NAVAL BIODYNAMICS LABORATORY  
NBDL-91R003

## HUMAN FACTORS ASSESSMENT OF USCG 47-FT MOTOR LIFEBOAT

Technical Report

## **I: Preliminary Evaluation of Ergonomic and Safety Deficiencies**

Figure II.22. Window/heaters junction box in enclosed bridge overhead.

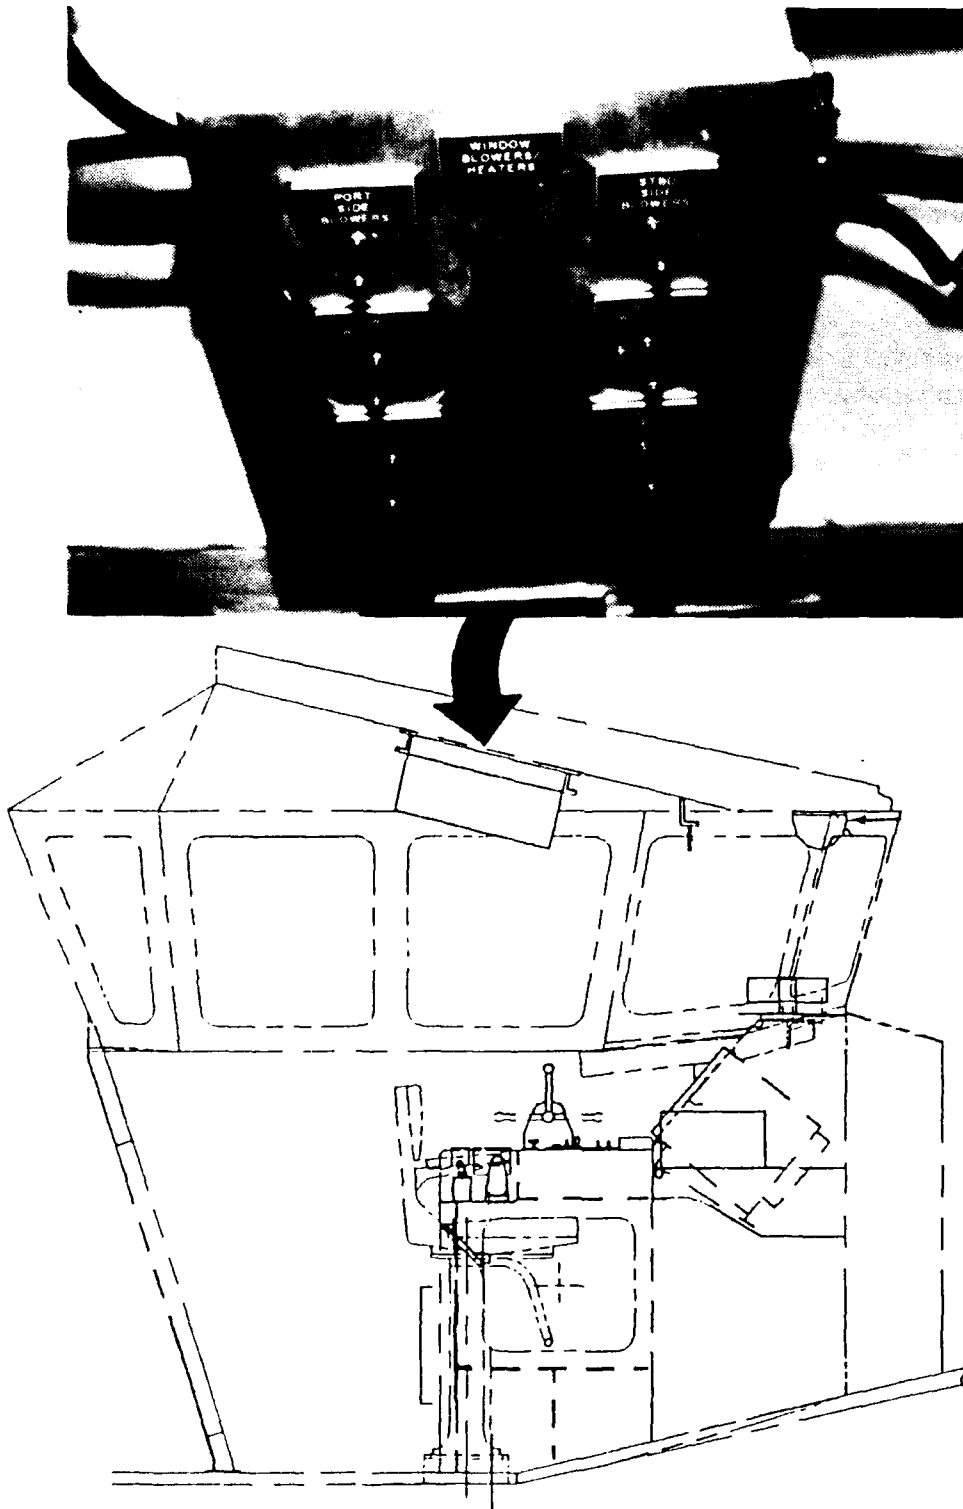
The window blower/heater switch panel is mounted on the overhead at the centerline and between the two forward seats (see Figure II.22). The window washer button is located on the dashboard in front of the portside chair. The window wiper control panel is located directly aft of the radar plotter keyboard.

- Group windshield cleaning controls together on the forward dashboard or in the overhead.
- To increase the visibility of the operator an additional window in the hatch door to the open bridge may be installed. As an alternative, the current window can be enlarged. In both cases the operator would have a wider view of the open bridge and aft of the boat, particularly during towing operations.

Figure II.23. Open bridge navigation and lighting switch panel.

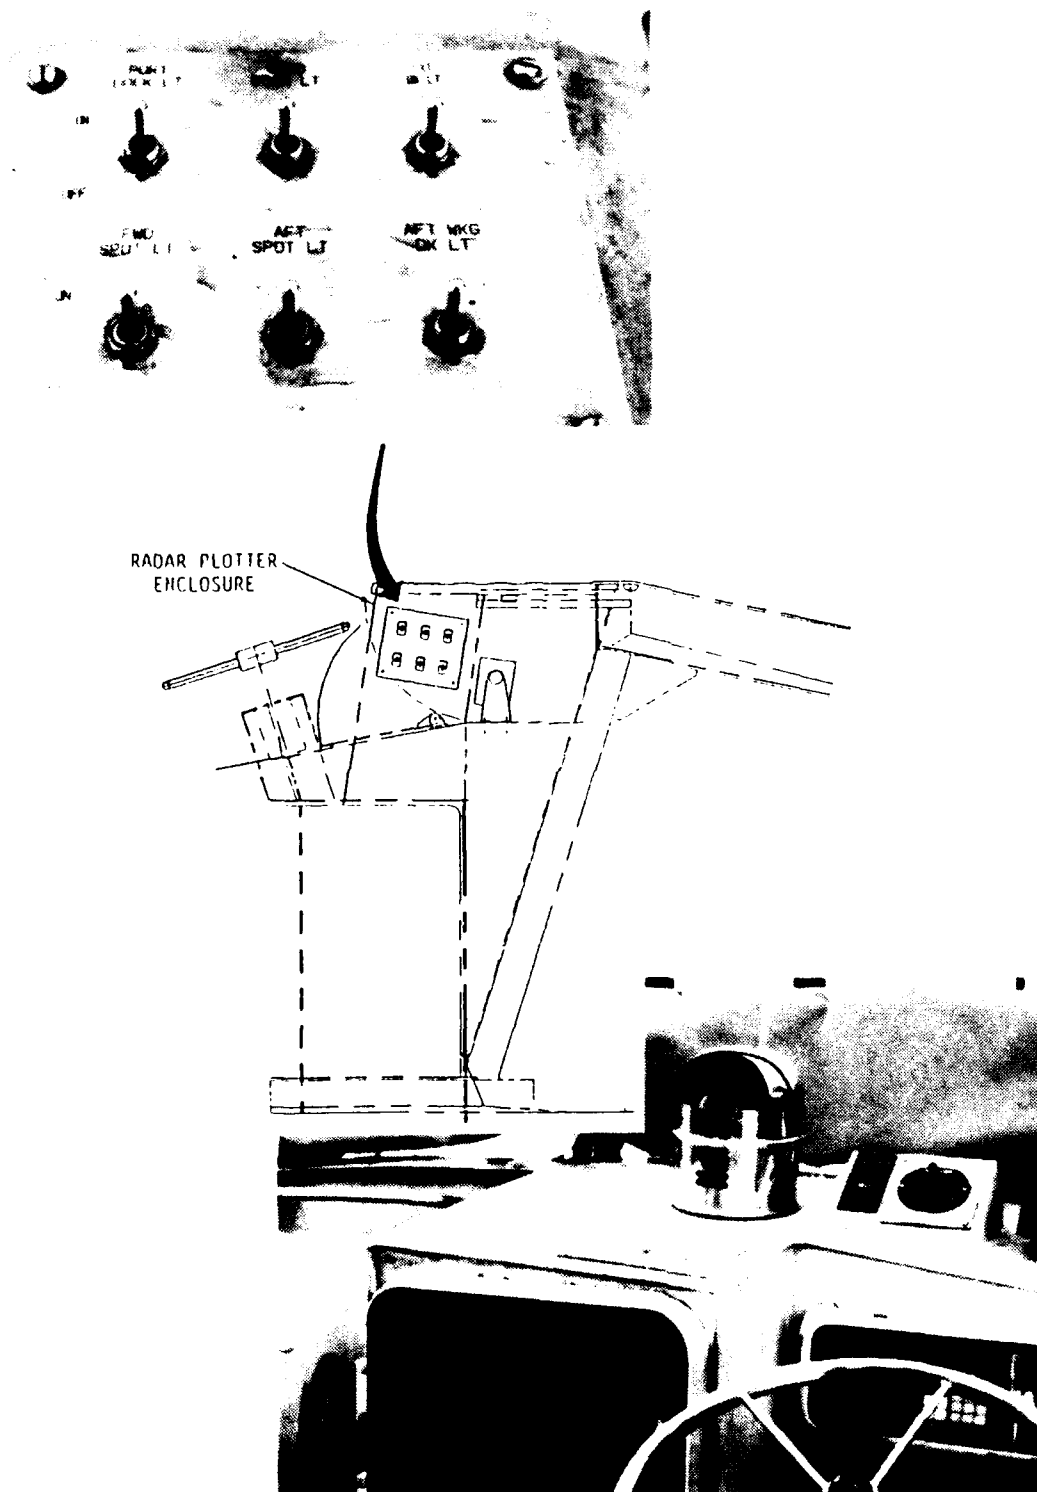
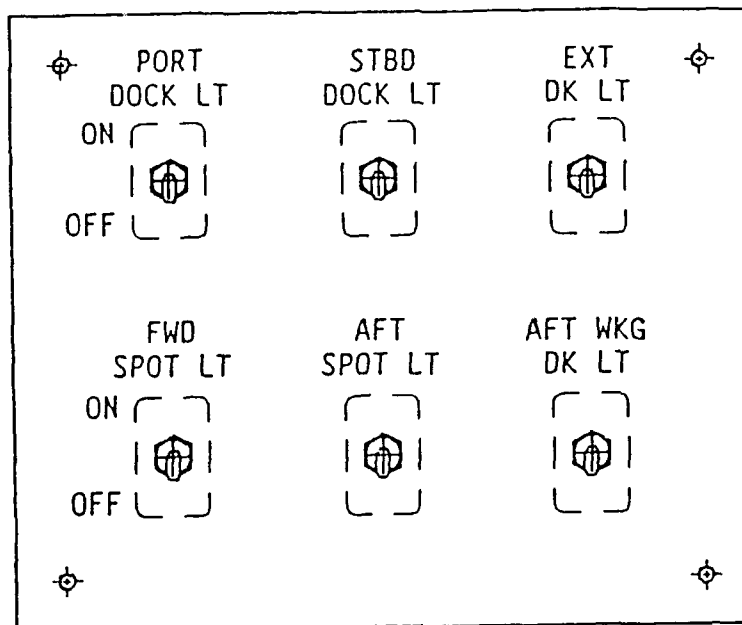
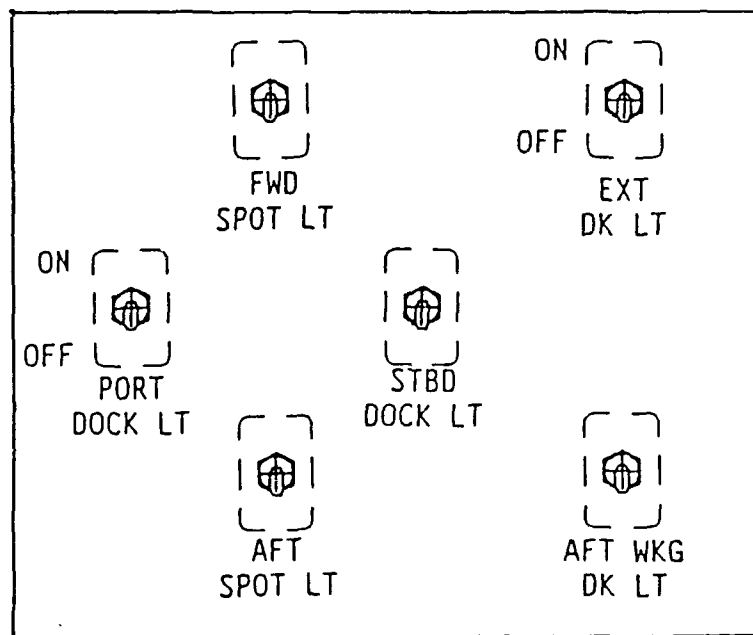
- Navigation light switch panel: Rearrange the lighting switch panel located on the radar plotter enclosure on the open bridge (see Figures II.23 and II.24). The switches should be arranged to correspond to their positions on the boat. A diamond shaped arrangement would be appropriate and useful for crew operations (see Figure II.25). Additionally, all switches with dual controls, like the navigation light switches, should eliminate the up/down convention as this will change with the positioning of one set of switches. It is recommended that a horizontal configuration that uses LED lights to indicate the on/off condition be used in this application (Figure II.26). This prevents a confusing situation and requires the operator to physically notice the switches current operation. The addition of the LED indicator light will show the operator, immediately, the condition of the switch.
